Response to Comments

PROPOSED TEMPORARY OPEN STORAGE OF CONSTRUCTION MATERIALS AND MACHINERIES FOR A PERIOD OF THREE YEARS IN “AGRICULTURE” ZONE

LOT 356 OF D.D. 87, FU TEI AU, NEW TERRITORIES

S.16 Planning Application No. A/NE-FTA/240

Figure 1 Drainage Plan

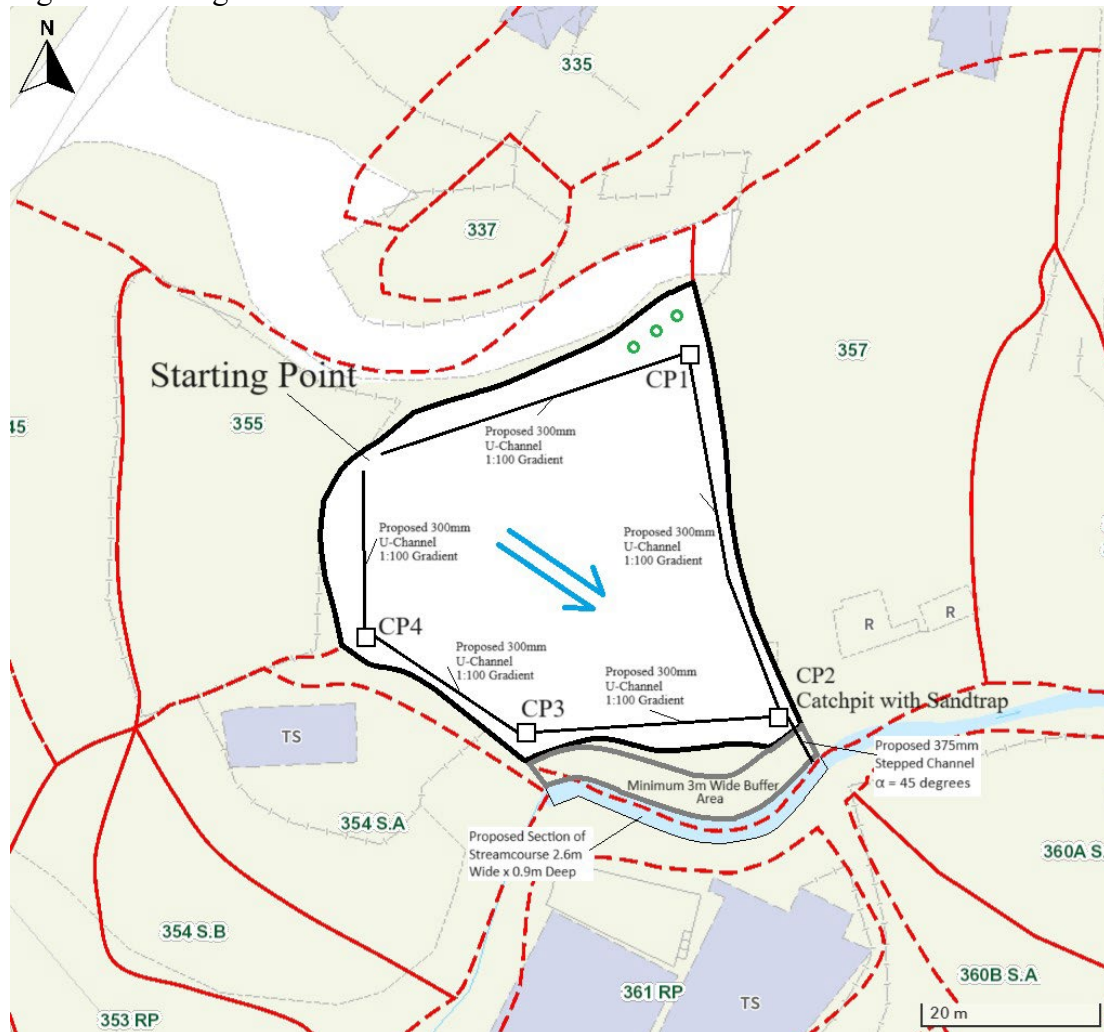
Departmental Comments	Applicant’s Response
<p><u>Chief Engineer/Mainland North, Drainage Services Department</u></p> <p>1. As stated under the Para. (b) in our memo dated 26.1.2024, the applicant shall be required to place all the proposed works at least 3m away from the top of the bank of the existing streamcourse. However, according to the FI submitted by the applicant (Para.1.1.2 under the drainage proposal refers) , works on the streamcourse was carried out and concrete blocks were placed along the streamcourse without prior consent from DSD. The applicant should reinstate the original streamcourse and place all proposed works, including the concrete blocks, at least 3m away from the reinstated streamcourse.</p>	<p>The modification works were performed as emergency measures in response to the flooding incidents in recent years. As the majority of the stream course falls within or between private lots, we understand difficulties for the government to perform necessary modification works on the streamcourse. And as the rain season is fast approaching, it was necessary to make improvements to avoid further flooding. After detailed calculations, widening of the streamcourse has increased the capacity of the streamcourse significantly, however, it was not adequate to receive the runoff from the entire catchment. The applicant proposes to push the northern bank 0.4m back, thus widening the streamcourse by 0.4m to 2.6m and deepen the stream course to 0.9m. Please find attached revised drainage proposal with calculations showing that the proposed improvement works would increase the streamcourse’s capacity such that it has adequate capacity and has satisfactory condition to cater for the entire catchment area. The applicant also proposes to push back the concrete blocks 3m to create a buffer area. The buffer area will be at +23mPD with a slight gradient sloping towards the streamcourse. Below please find the revised drainage plan and cross section detailing buffer area and streamcourse.</p>
